Village of Arlington Heights
Plat and Subdivision Committee
Community Room, 3rd Floor
Arlington Heights Village Hall
33 S. Arlington Heights Road
Arlington Heights, IL 60005
May 25, 2016
6:30 PM

Item: Carnica Auto Detail - 208 W. University Dr. - T1553

STAFF DEVELOPMENT COMMITTEE REPORT

Item: Sunset Meadows Safety Netting - 700 S. Dwyer Ave. - T1555

FLOOR PLAN
SCALE: 1/8" = 1'-0"

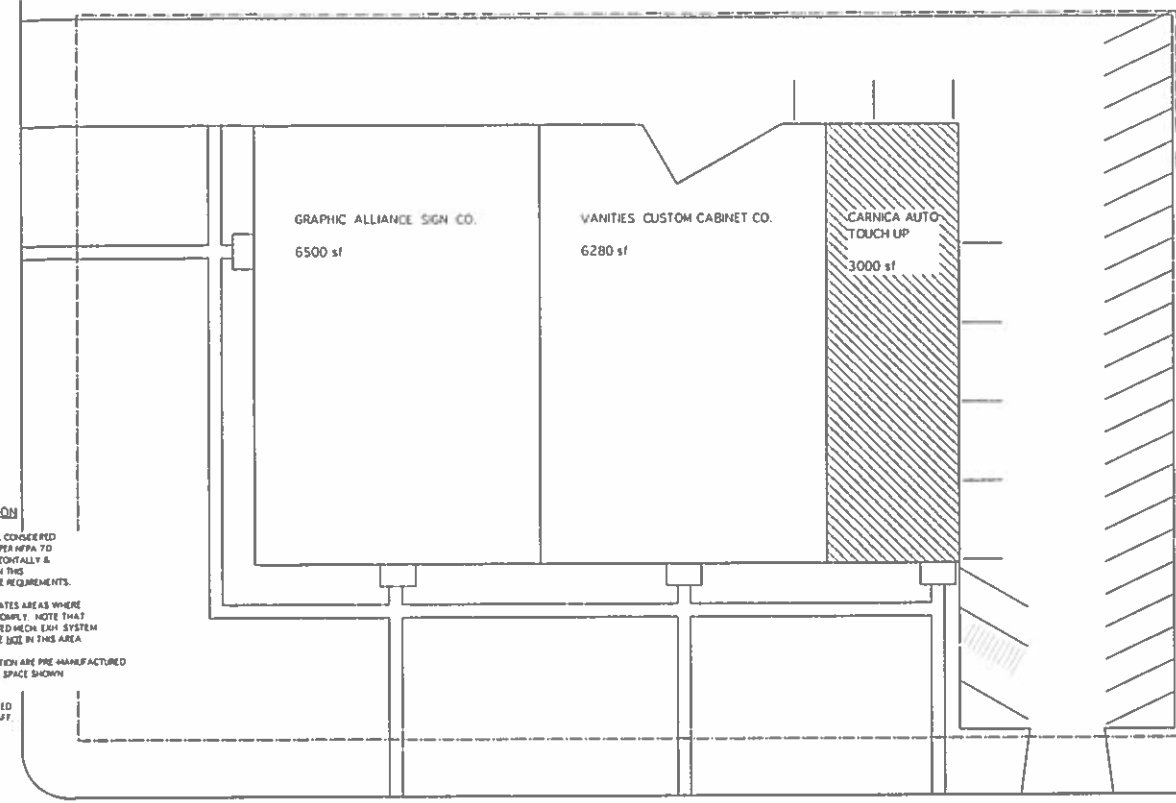
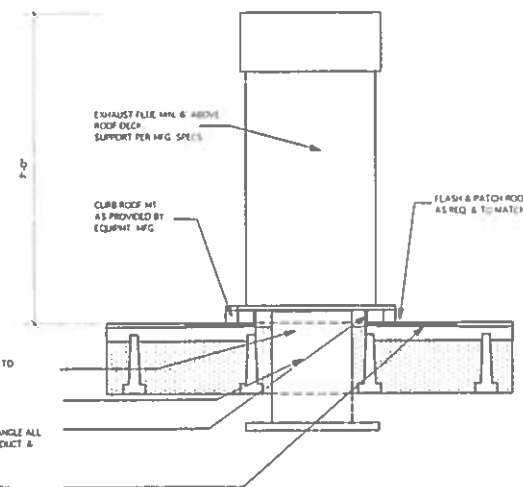
The petitioner has stated that “almost all of the repairs we do are completed in one day, and vehicles would not be kept outside in any state of repair”. Additional clarity is needed on what vehicles will be kept outside. The applicant should clarify what “any state of repair” means. Will vehicles awaiting repair be kept outside? Will vehicles that have already been repaired be kept outside? What if repairs are not completed in one day; where will the vehicle be stored in this instance? Additional details are needed to determine the effect of any exterior stored vehicles on the appearance of the property and on the parking capacity of the site.

1. The Petitioner shall provide a parking inventory/survey over a two day period (of only weekdays) of the available parking spaces on the subject property.
2. The Petitioner shall clarify what vehicles may be stored on the exterior of the site.
3. These are preliminary comments only and should not be relied upon as identification of the only major issues. The Staff Development Committee reserves the right to change its position on issues upon submittal of a formal application and detailed review.
